**METROPOLITAN GOVERNMENT OF NASHVILLE AND DAVIDSON COUNTY**

**STAFF RECOMMENDATION**  
**1202 Gartland Avenue**  
**September 21, 2016**

**Application:** New construction—detached accessory dwelling unit; Setback determination

Figure 2. The neighboring outbuildings have a similar side and rear setback as proposed

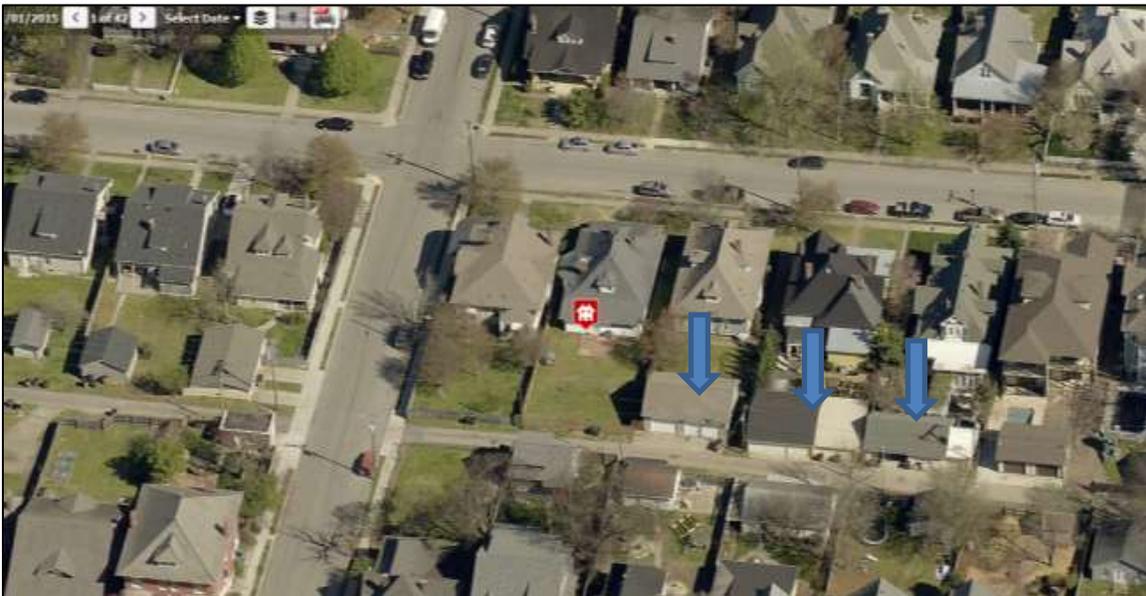
Rear setback determinations have routinely been approved for DADUs and outbuildings because outbuildings close to the rear of a lot is the historic context and does not directly affect neighboring properties because of the alley buffer; however, Staff is concerned that two feet (2’) may be too little. Although rear setbacks are routinely approved, and appropriate in this case, staff recommends a rear setback of at least five feet (5’) to allow for future alley improvements and an appropriate turn radius. (1210 Gartland was permitted at six feet (6’) from the rear property line. 1208 Gartland was permitted at five feet (5’) from the rear property line. 1206 Gartland was an addition to an existing garage located on the property line.)

Staff recommends approval of the rear setback determination to five feet (5’); staff recommends that the side setback meet base zoning requirements, also at five feet (5’).

SITE PLAN  
 SCALE 1" = 10'

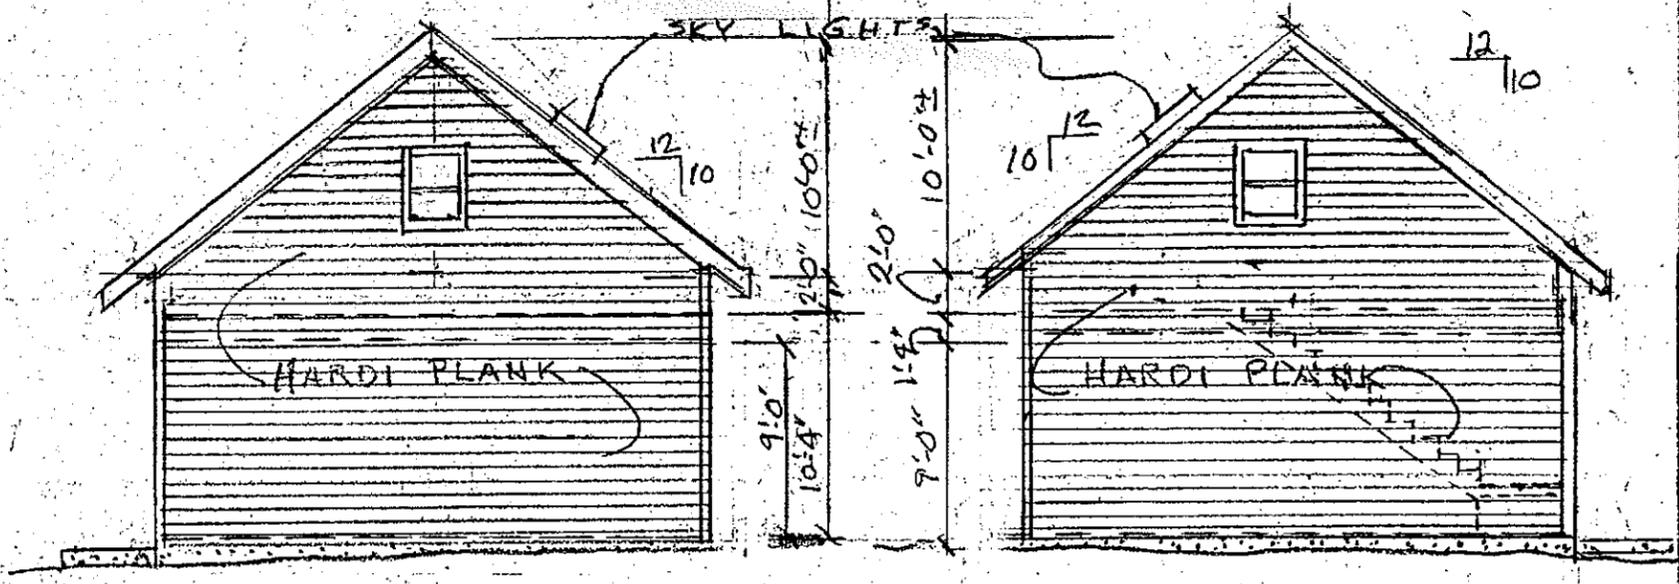
Setbacks: The new DADU requires a setback determination for the side and rear property lines. When an outbuilding has a footprint greater than seven hundred square feet (700 sq. ft.), base zoning requires that the structure be located twenty feet (20’) from the rear property line, and five feet (5’) from the side. In this case the structure is proposed at two feet (2’) from the rear property line, and three feet (3’) from the left side. The Commission has the ability to set setbacks that are appropriate for the lot and the district; however, the Commission has never altered the ordinance’s side setback requirement for DADUs. The Commission has found that the five-foot (5’) setback requirement is appropriate for DADUs in all instances where a DADU meets zoning.

|   | MINIMUM                             | PROPOSED |
|---|-------------------------------------|----------|
| <b>Rear setback</b>                                     | 20'                                 | 2'       |
| <b>R side setback**</b>                                 | 5'                                  | 3'       |

RIGHT SIDE ELEVATION  
SCALE 1/8" = 1'-0"

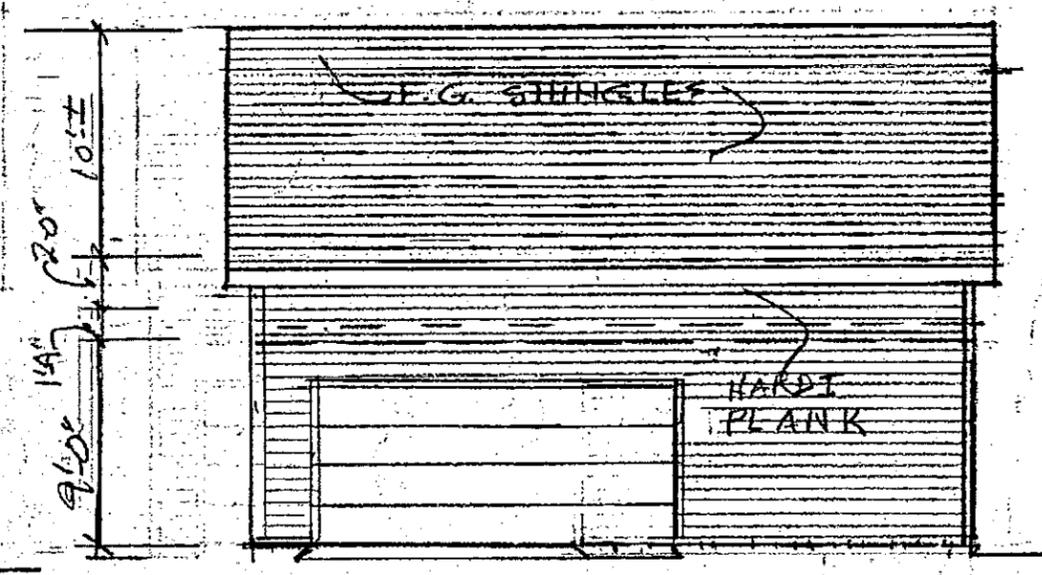
The roof includes flat skylights. They are shown on the side elevations but the location is not evident on the front and back; staff requests that the drawings be updated to show the location of the skylights. The form and roof slopes are similar to historic outbuildings, the project meets Section II.B.8 of the design guidelines and section 17.16.030.G.8 of the ordinance.

1. That the rear setback be a minimum of five feet (5') and the side setback be a minimum of five feet (5');
2. Drawings show the location of skylights;
3. Staff approve the final details, dimensions and materials of windows, doors, and garage doors;
4. Fiber-cement siding have a maximum reveal of five inches (5"); and
5. Staff receive a copy of the filed restrictive covenant for the detached accessory dwelling unit prior to issuing the permit.
